Re: Town of Yorktown Tree Committee
Comments New York City Dept. Environmental Protection
DEP Log #: 2020-CNC-0078-SQ.2

Re: Teatown Lake Reservation Dredge Project
3-5554-00145/00011,12 (EF, FW, WQC) NOIA dated 12/21/2023

Teatown Lake Reservation is committed to protecting the environment as it's core mission and on behalf of my client I am pleased to be able to answer the questions and request for additional information in the Notice of Incomplete Application (NOIA) for the Joint Application that was submitted on 12 September 2023.

TEATOWN LAKE DREDGING

**GEOTUBE STOCKPILE
SITE NO. 2 PLAN**

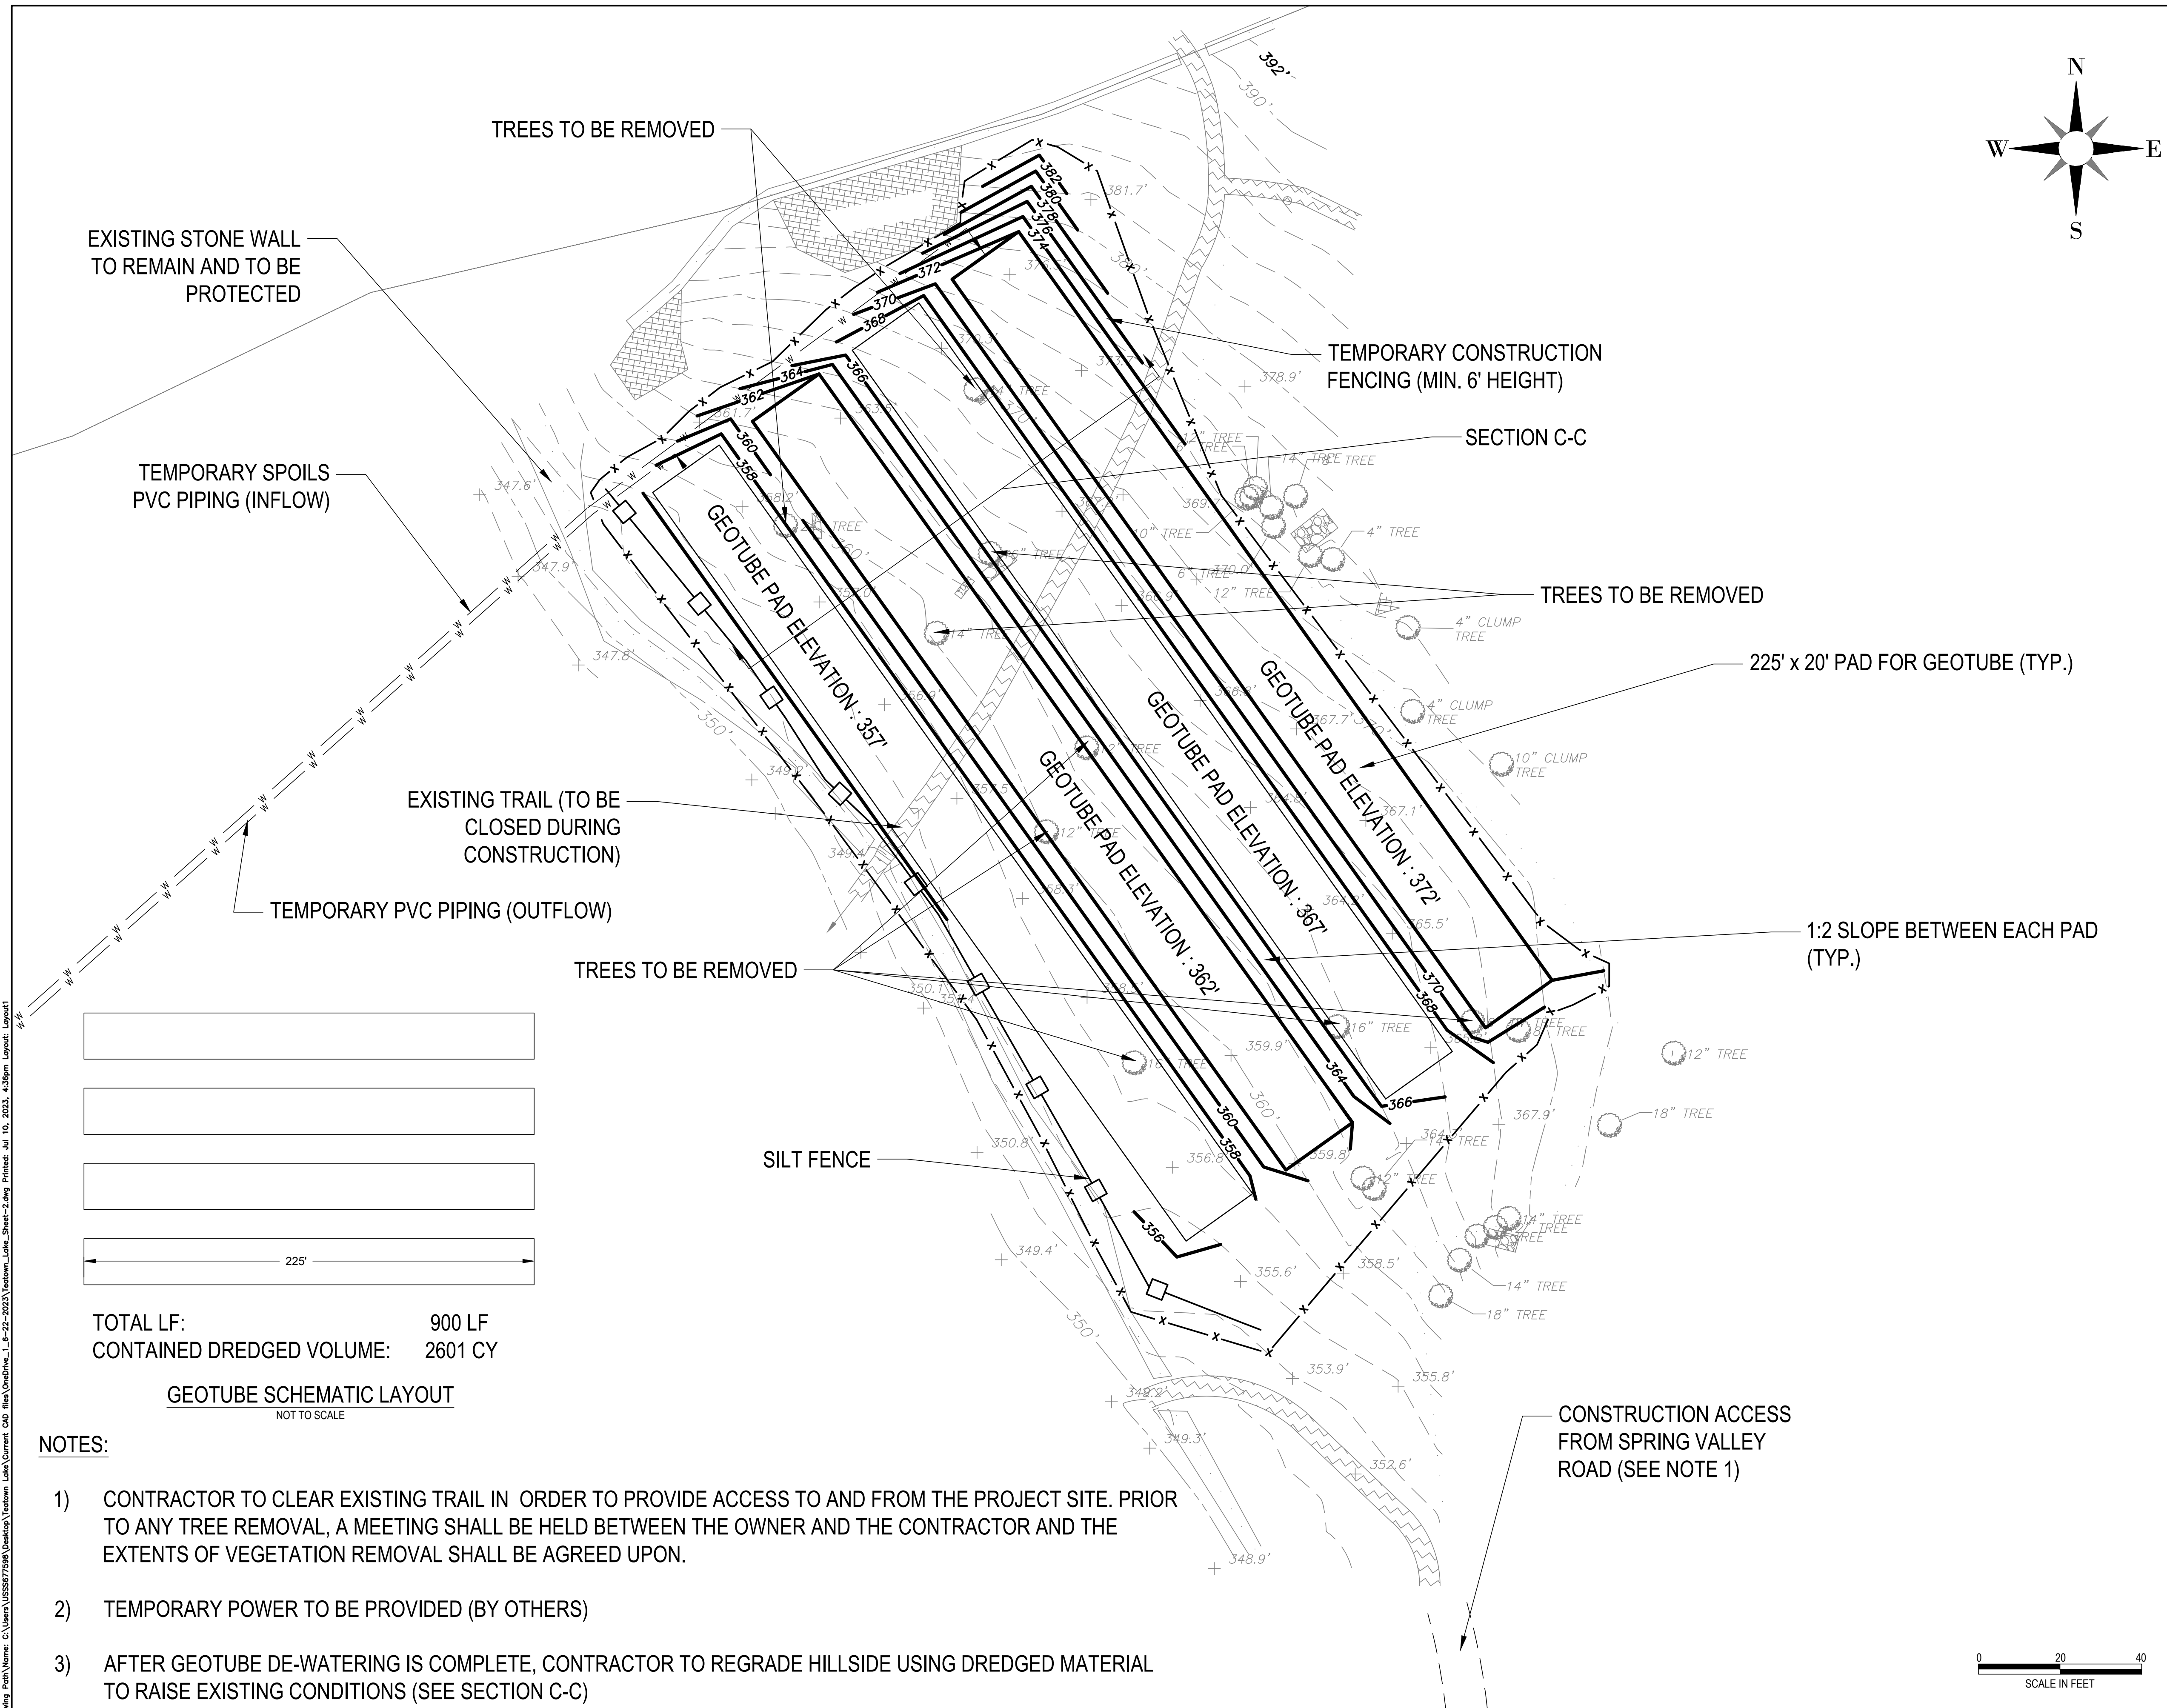
- d) PrDredge material to be used at Geotube location #2 as part of Hidden Valley Meadow restoration. Please see sheets 3 and 6 of 9 of the revised plan set.
- e) The dredge unit will be lowered by crane into Teatown Lake from Spring Valley Rd., approximately 400 feet east of the junction of Teatown Lake Rd. and Spring Valley Rd.. Access to geotube location #1, Blinn Rd. parking lot, will be accessed from Blinn Rd. Access to the geotube location #2 will be from an existing access road. The entrance is approximately 200 feet east of the junction of Blinn Rd. and Spring Valley Rd.
- f) Please see the attached spec sheet for the hydro-dredge unit, Mudcat SP-915.

DRAWING NUMBER: GR101 SHEET NUMBER:
7 OF 9

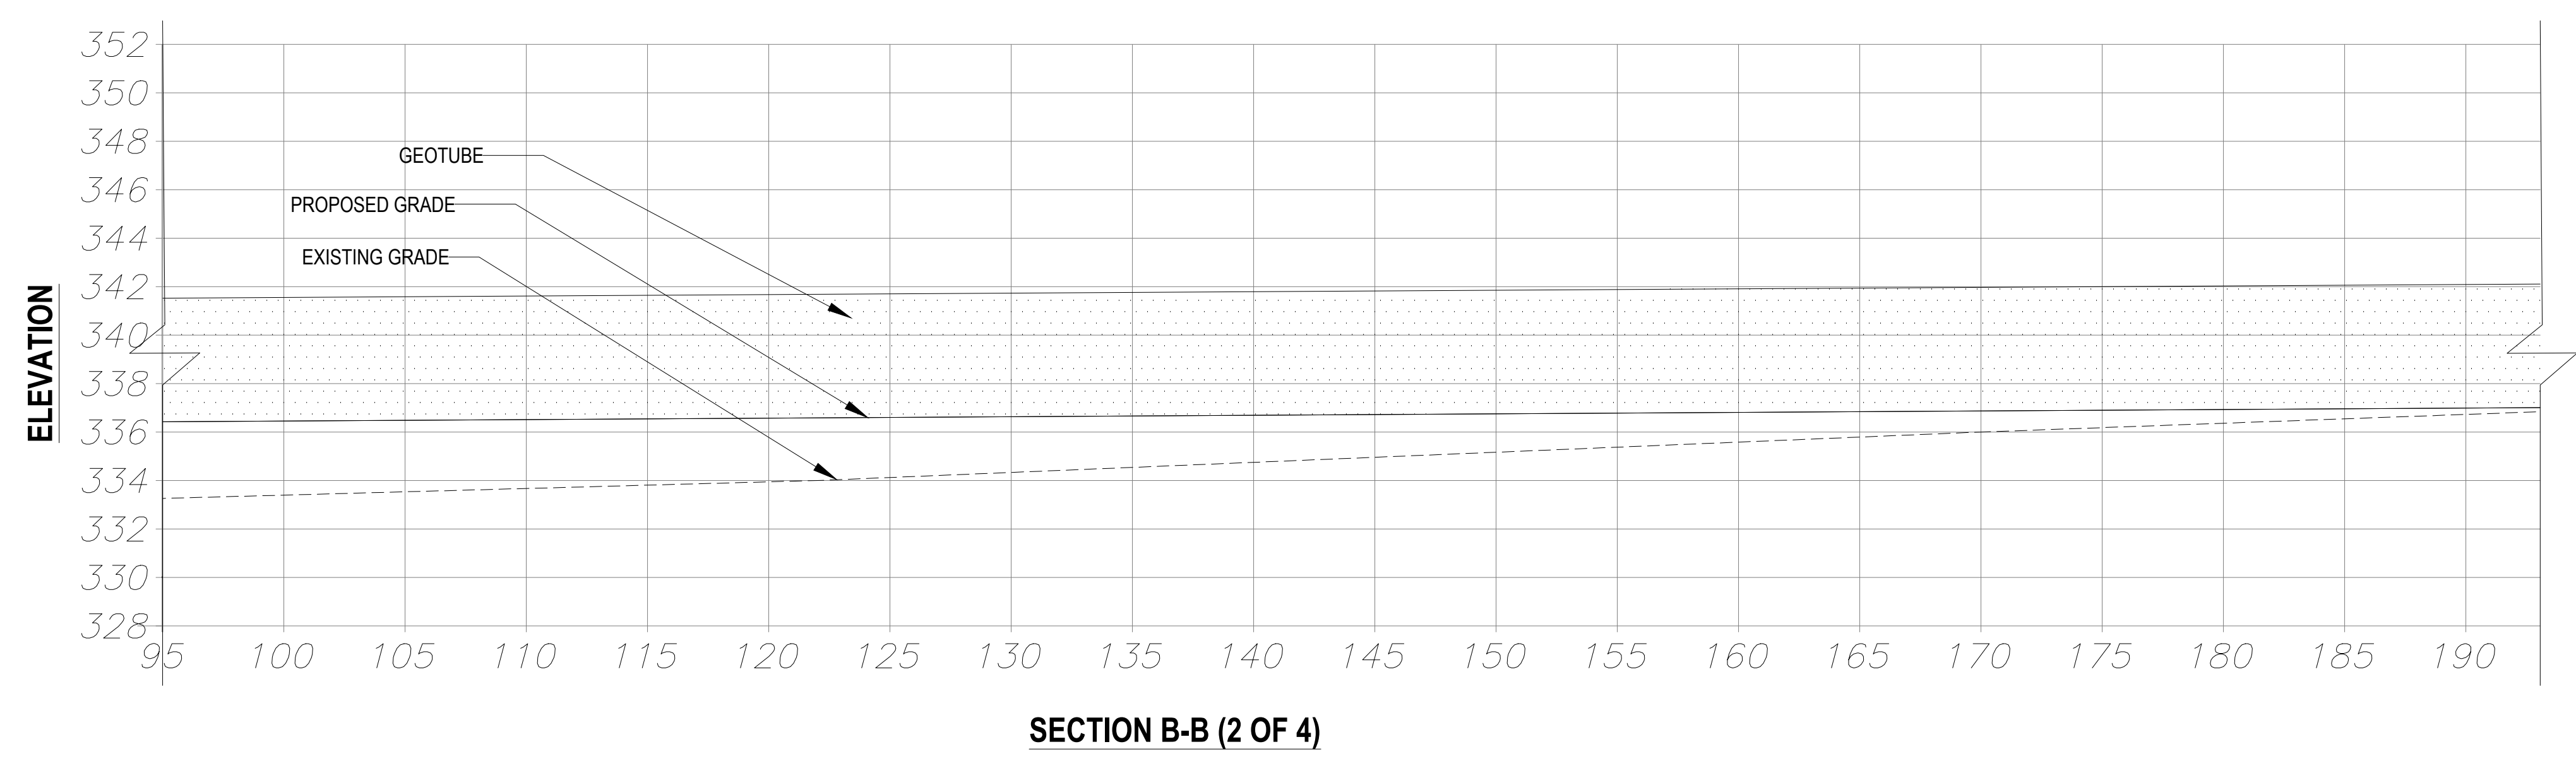
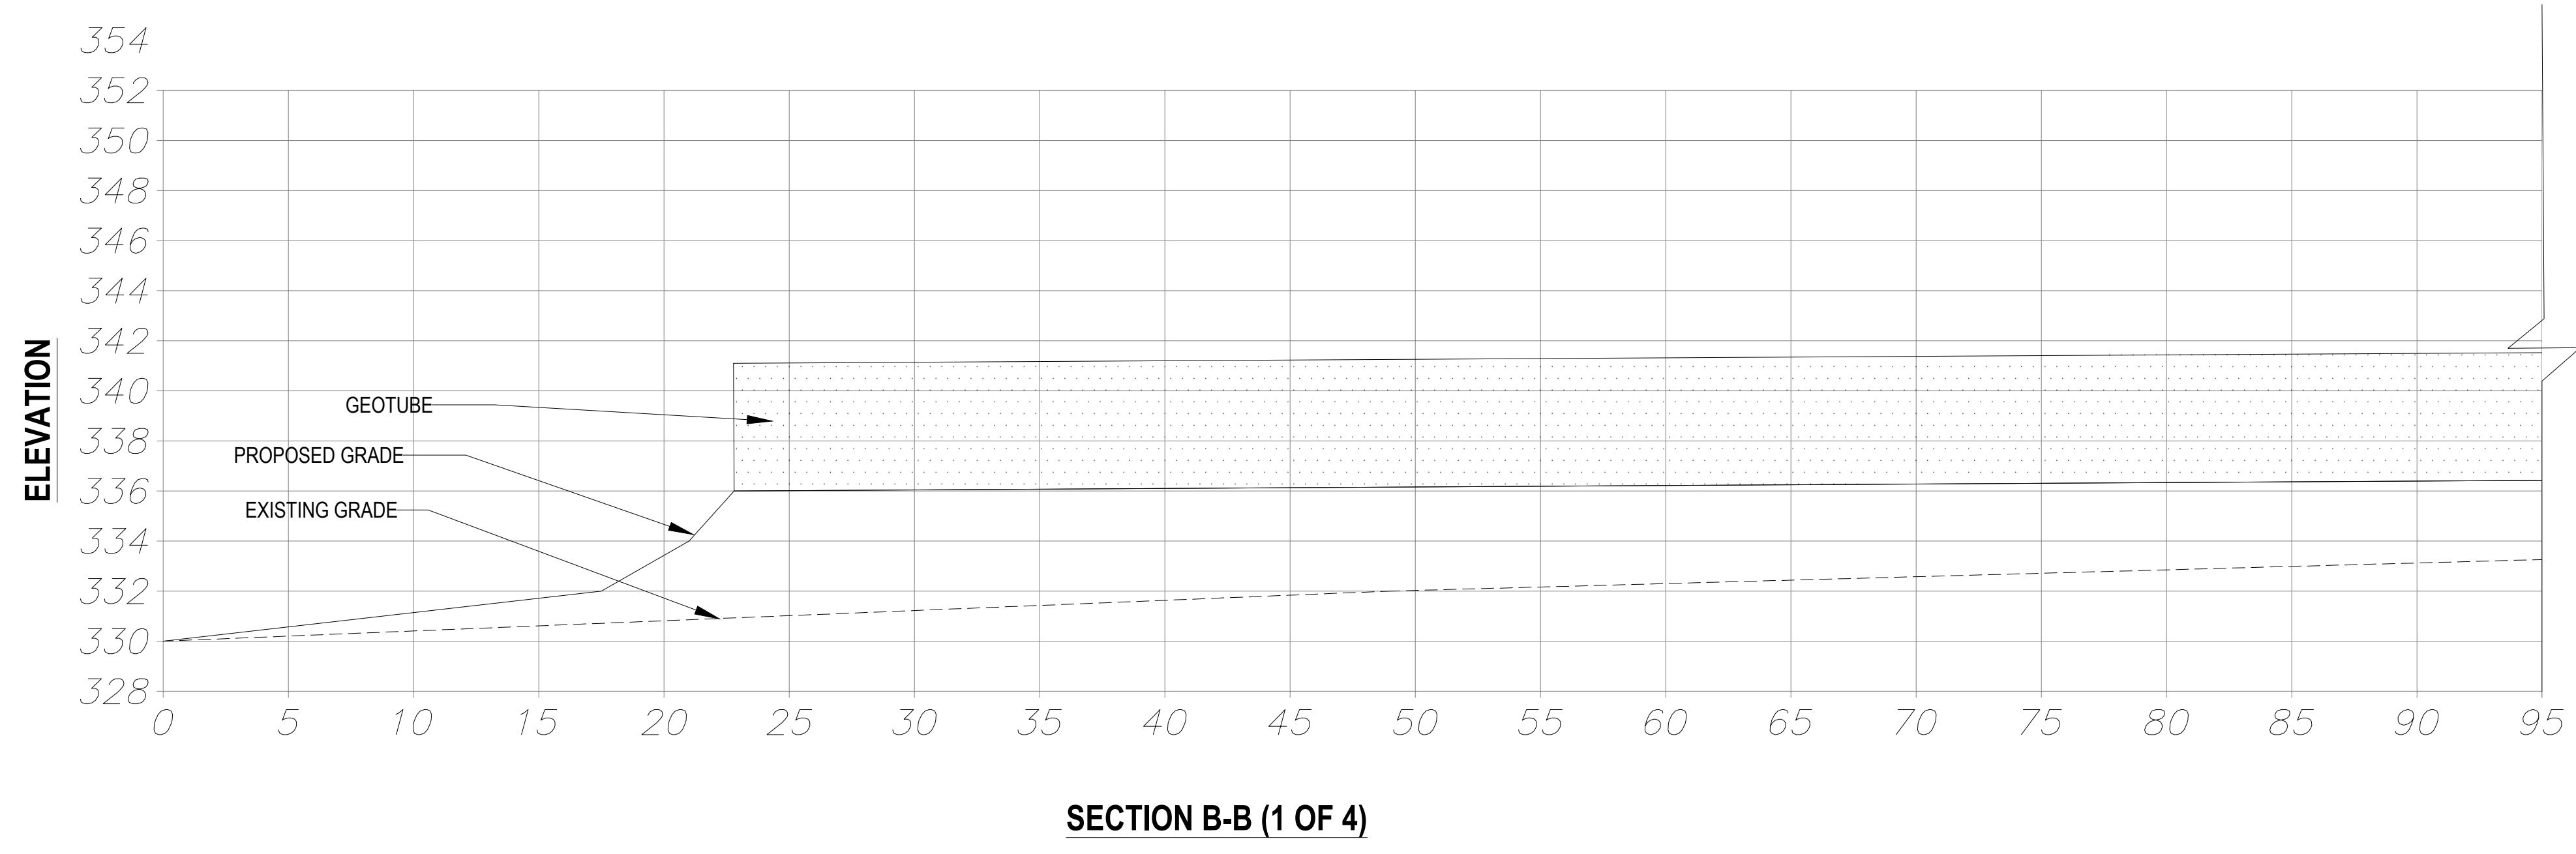
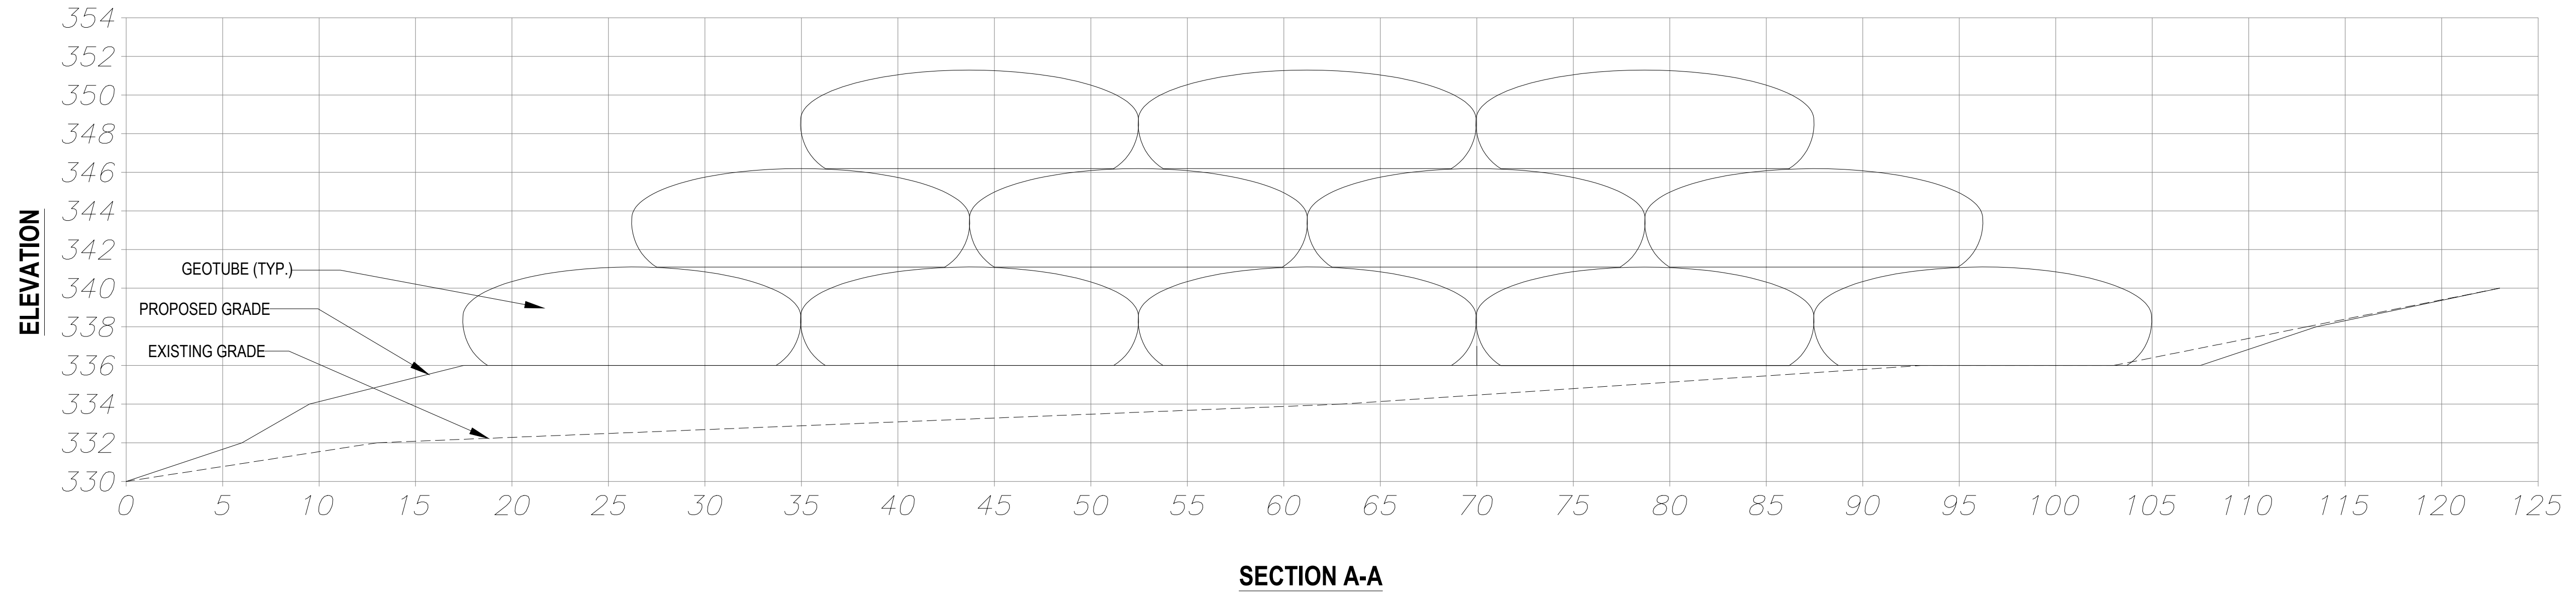
- a) Please see profile and cross section sheet 4 of 9 of the revised plan set.
- b) Please see the attached bathymetric survey of Teatown Lake.
- c) Shorelines to remain as is, extent of channel will be 12 feet from existing shoreline.

Figure 2. Trees to be removed Hidden Valley North Field Meadow

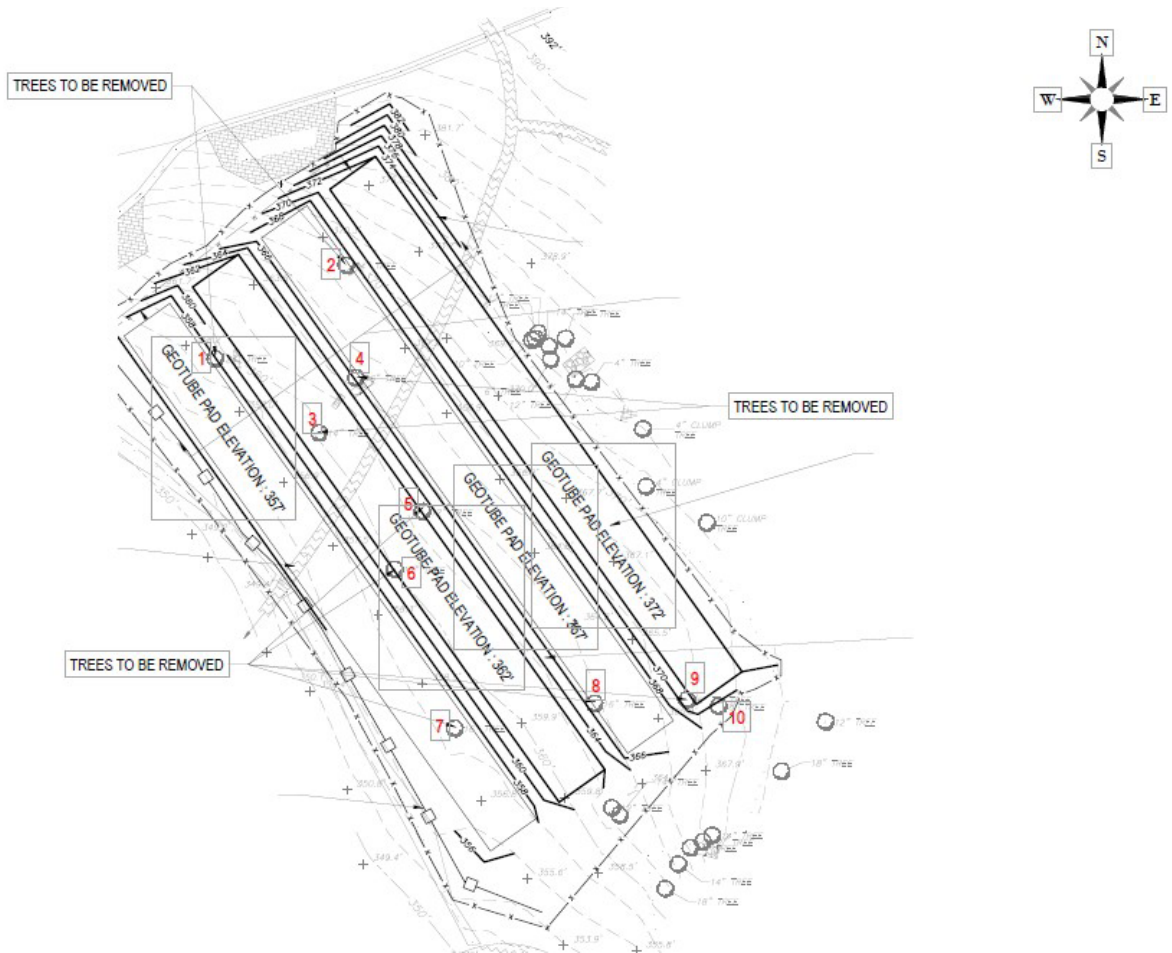
At the request of the Tree Commission Advisory Committee, I have also included a site plan for the Hidden Valley dewatering location that includes a table of the species and diameter breast height of the trees to be removed.

The hill side will need to be prepared by cutting for “terraces” that will hold the Geotubes. Access for construction equipment will be from Spring Vally Rd, on property owned by TLR. Sheet 4 of the plan set has site preparation details. Nine trees will be removed from the hillside as part of the site preparation. One of these trees is a double stemmed flowering dogwood with one trunk. It was measured twice (“trees” 9 and 10). The full inventory of trees to be removed are shown and listed below.
